**Response to Submissions and Request for Information (DA22/14349)
Digital Advertising Sign – Pacific Highway, Lindfield**

This letter has been prepared by *Keylan Consulting Pty Ltd* (Keylan) on behalf of Sydney Trains (the Applicant) to address the Department of Planning and Environment's (DPE) Response to Submissions (RtS) request dated 13 December 2022 and Request for Information (RFI) dated 21 December 2022 in relation to Development Application (DA22/14349).

Figure 1: Aerial image with annotations (Source: Nearmaps and Keylan)

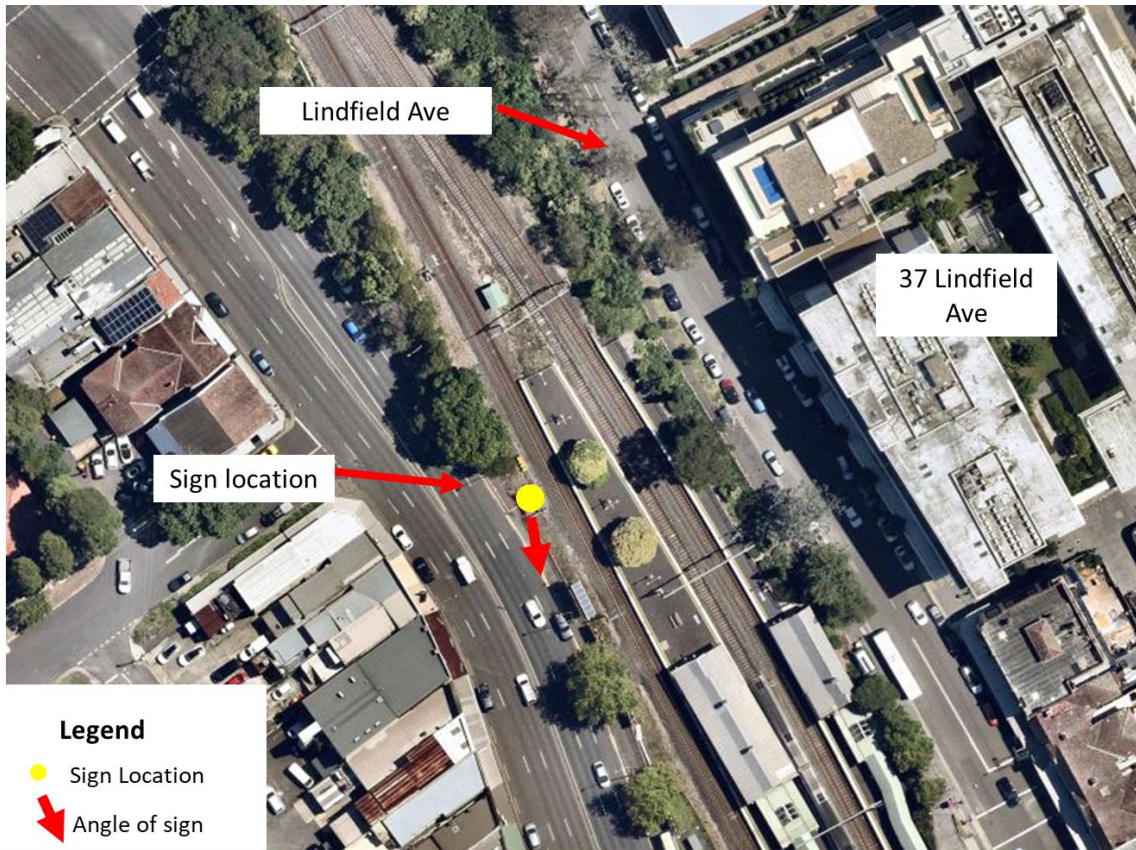
Ref.	Issues raised	Response
	<p><i>where the current IGA stands). In particular, the signage is approximately 50m to Lindfield Avenue residents and the signage operating hours as 24/7, spill lights will also create light pollution for 37 Lindfield Avenue residents. There are numerous 37 Lindfield Avenue residence bedrooms facing Pacific Highway. Hence, spill lights towards bedrooms can also be a nuisance to residents and may also trigger insomnia. But this has been glossed over in Appendix 5.</i></p> <p><i>If the signage could either move a little bit southbound closer to the bus station or the existing signage. Or consider changing the hours of operation might help remove spill lights for the residents nearby.</i></p>	<p>Impacts on the lower levels of 37 Lindfield Ave are considered negligible as the topography of the land and existing mature vegetation blocks most views of the sign (Figure 2).</p> <p>Impacts on the upper levels of the building are also considered minimal as:</p> <ul style="list-style-type: none"> • The proposed sign will be orientated south to face northbound traffic. It is noted, 37 Lindfield Avenue is located to the east of the sign as shown in Figure 1 below. • It is expected that any views of the sign will be limited to the side and rear panels which will be black and non-illuminated. The proposal is one-sided and there will be no advertising material located at the rear. <p>Further to the above, an updated Lighting Impact Assessment (LIA) is provided at Attachment C to this letter.</p> <p>The LIA demonstrates that 37 Lindfield Avenue will experience a luminance rating of 0.1 lux as a result of the sign. It is noted this is well below the maximum 2 lux as per the Australian Standards and therefore is considered appropriate.</p>

B3	<i>Dwell times between displays shall be no shorter than 10 seconds</i>	Noted and agreed.
B4	<i>A Road Occupancy Licence (ROL) should be obtained from Transport Management Centre for any works that may impact on traffic flows on Pacific Highway during construction activities. A ROL can be obtained through https://myrta.com/oplinc2/pages/security/oplincLogin.jsf</i>	Noted and agreed.
C	Public submission	
C1	<p><i>I want to object to the application or have the advertising signage slightly amended.</i></p> <p><i>I run a business and also own a property at 37 Lindfield Avenue, Lindfield.</i></p> <p><i>I appreciate this application with great detail, including light impact assessment. According to the information provided, it seems like the signage angle will also generate spill light which will impact the corner of 37 Lindfield Avenue residents (the residents above Lindfield Village</i></p>	<p>View impacts on Lindfield Avenue were assessed in the VIA at Appendix 5 of the original application. Notwithstanding, additional information is provided below at Attachment C.</p> <p>Figure 1 at Attachment C provides an aerial image of the site and surrounds, and Figure 2 provides an indicative photomontage from the lower level of 37 Lindfield Ave.</p>
